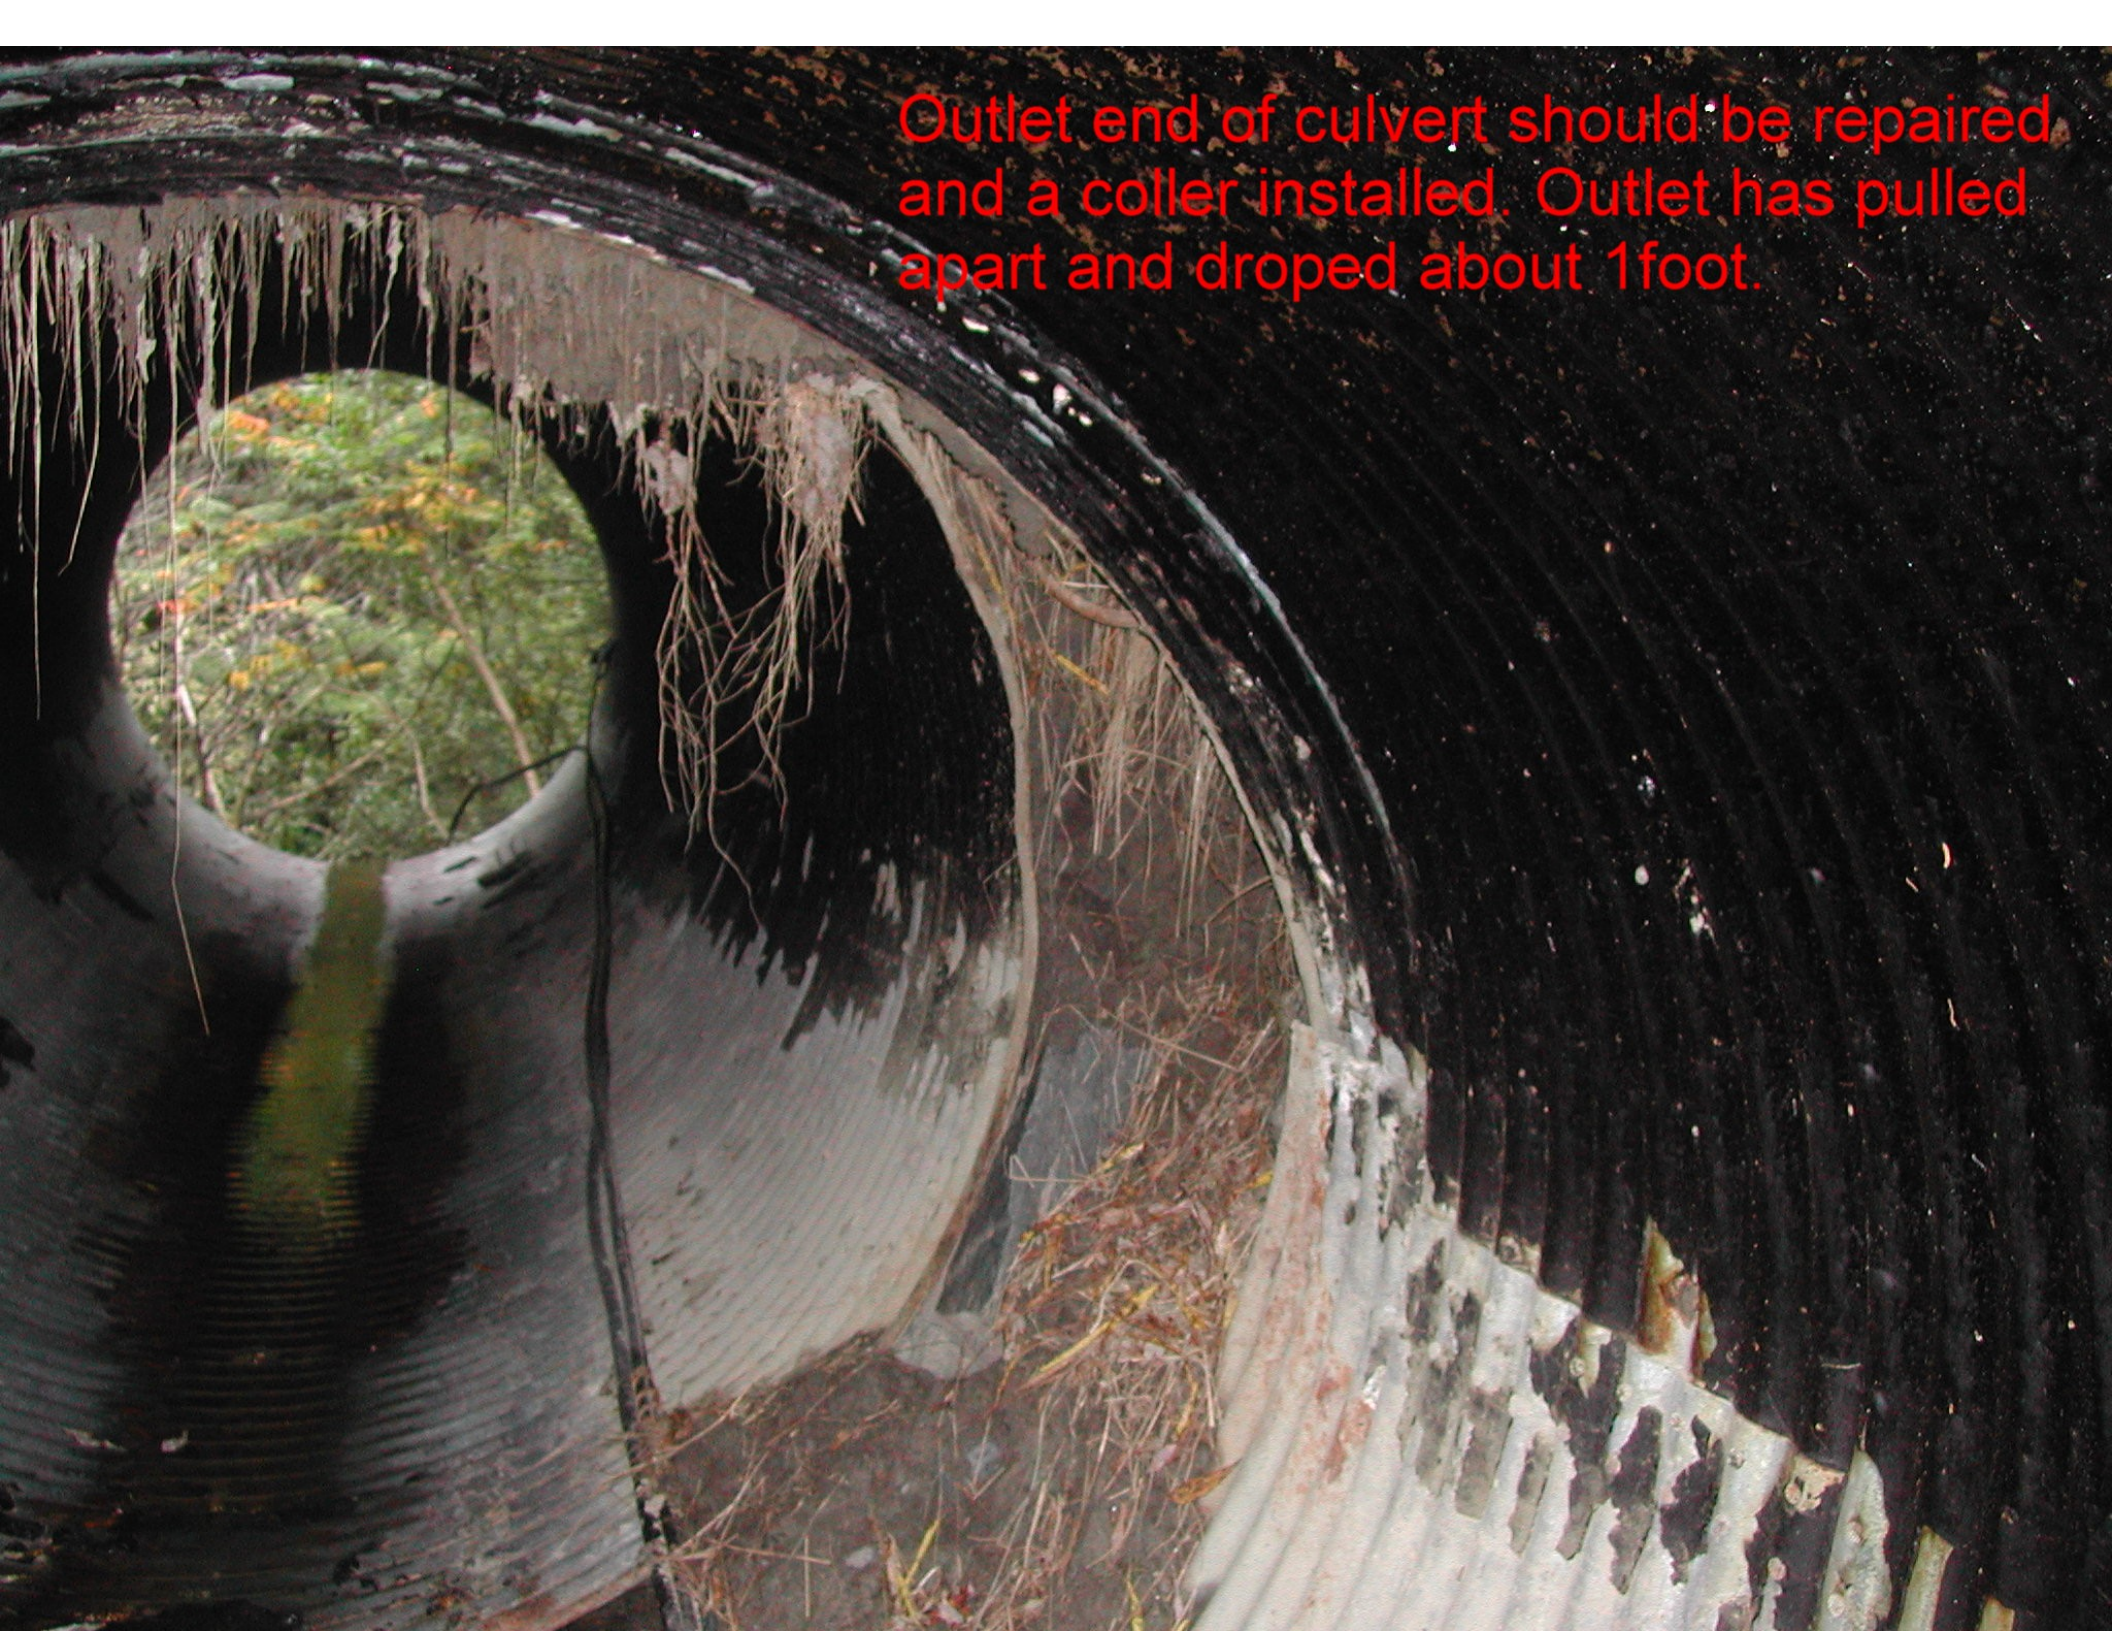
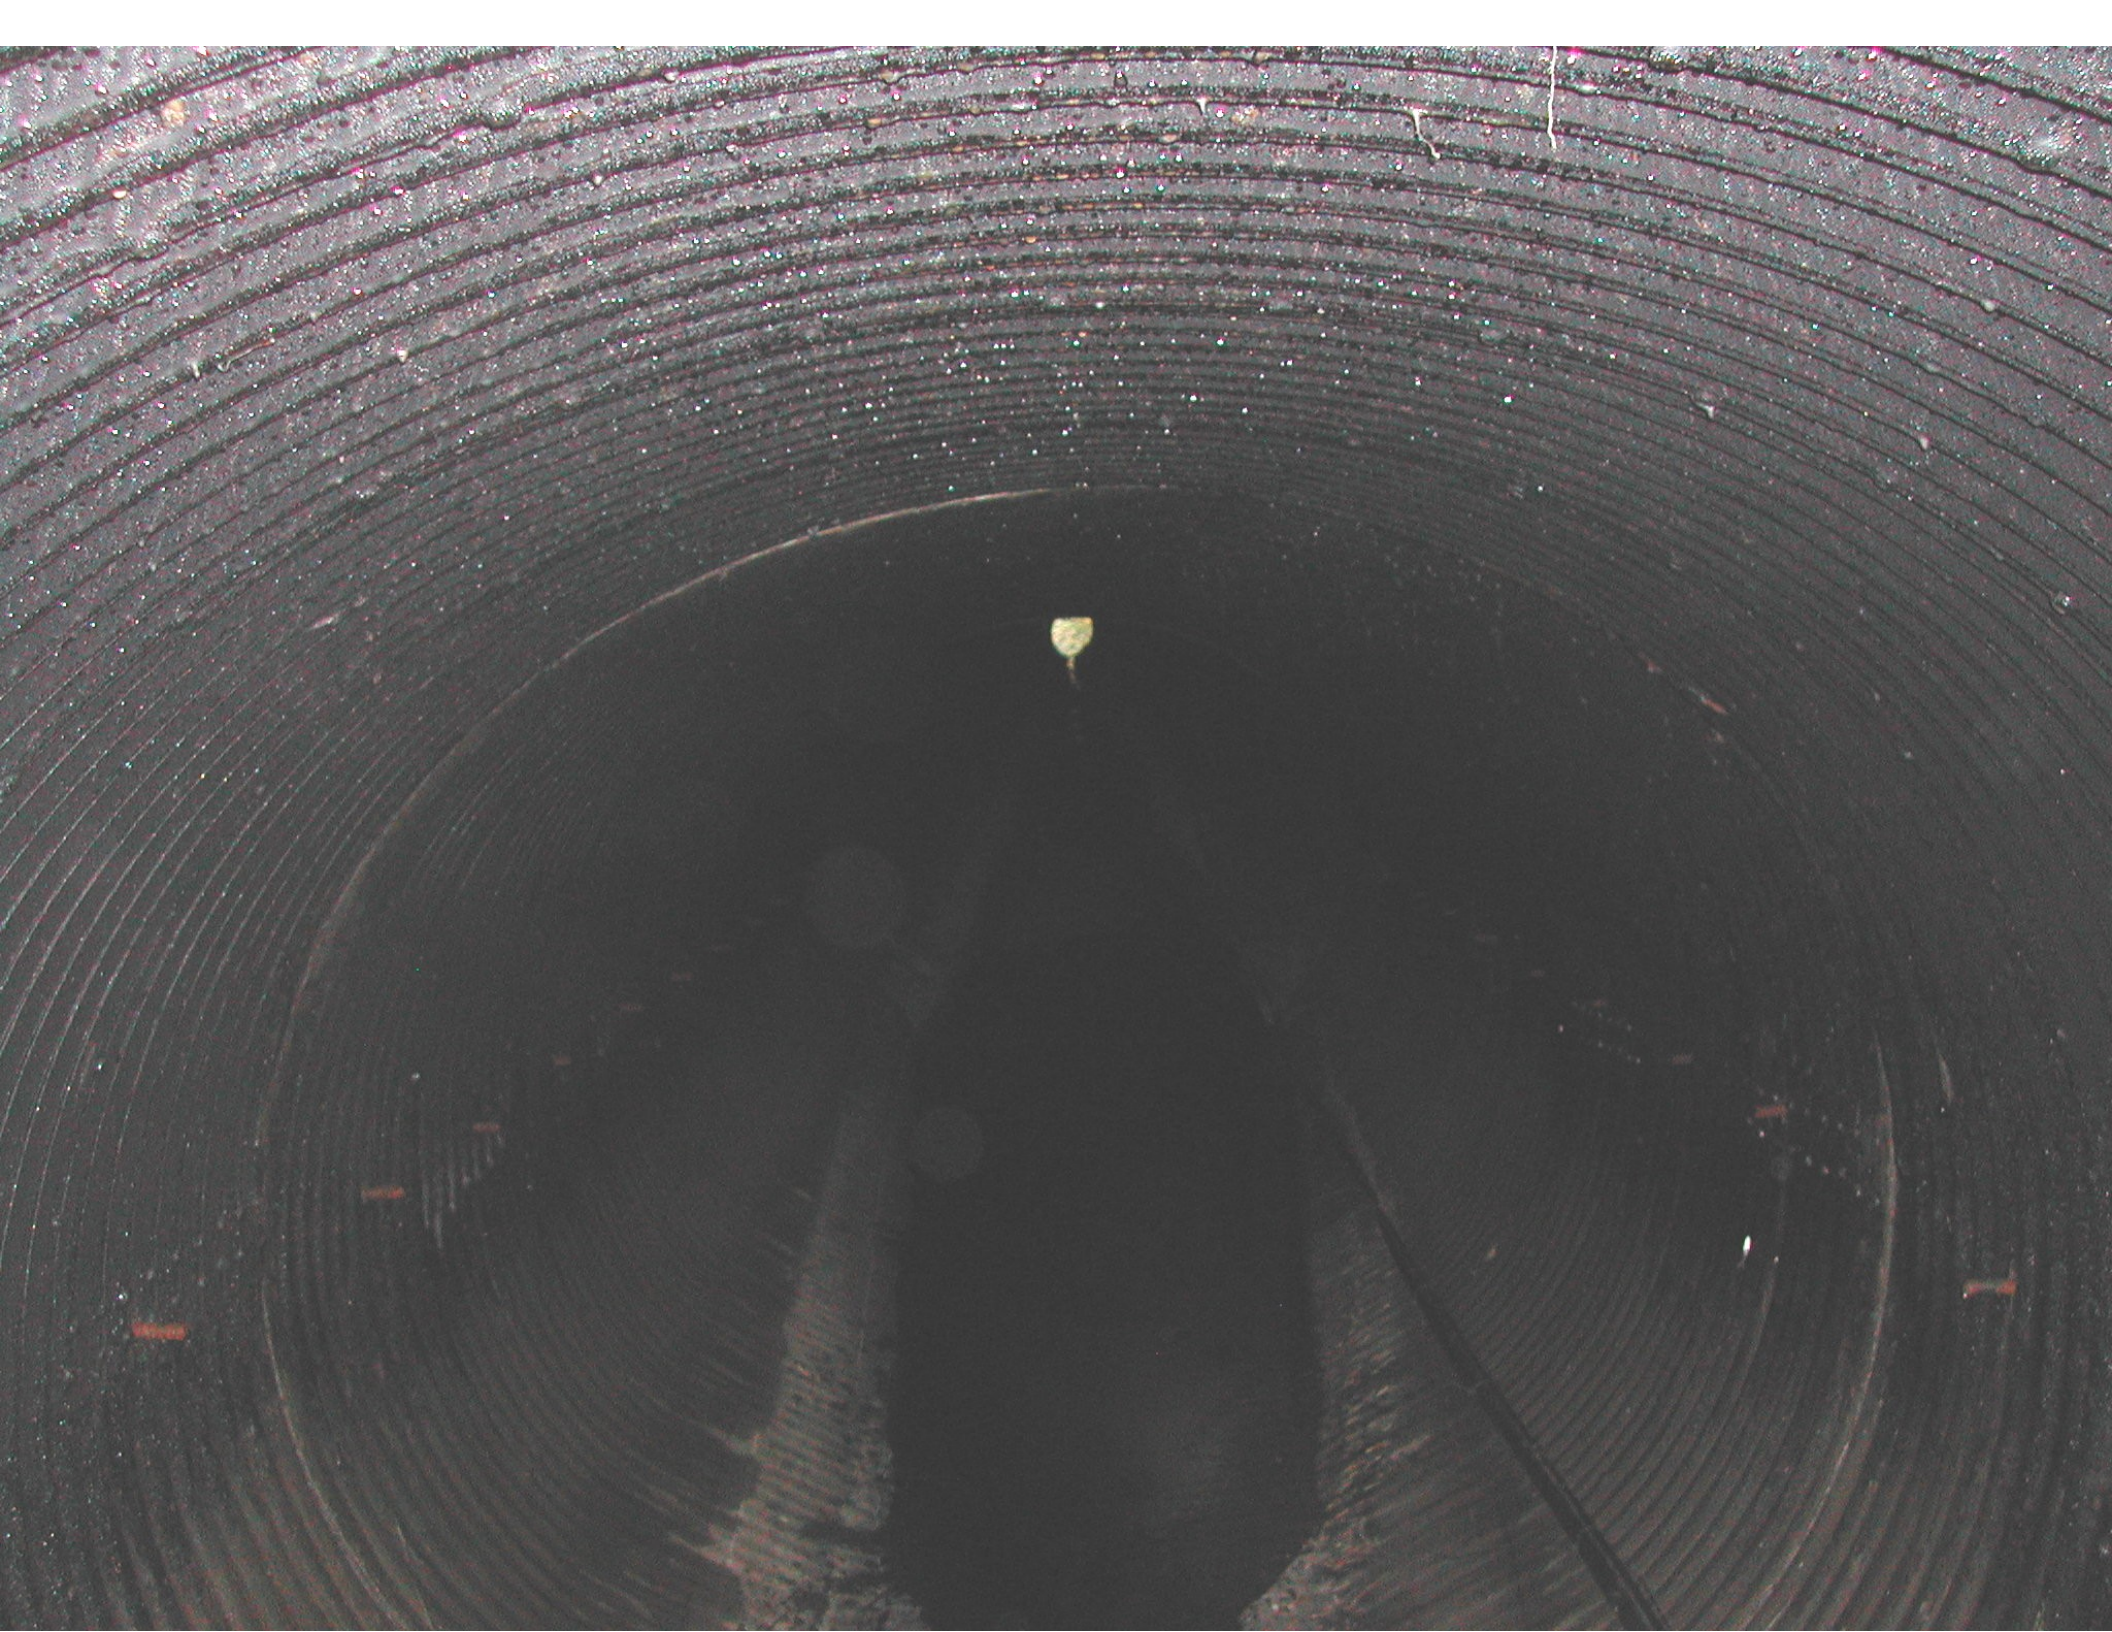
Outlet end of culvert should be repaired and a collar installed. Outlet has pulled apart and dropped about 1 foot.

Trees in channel at outlet need to be removed.
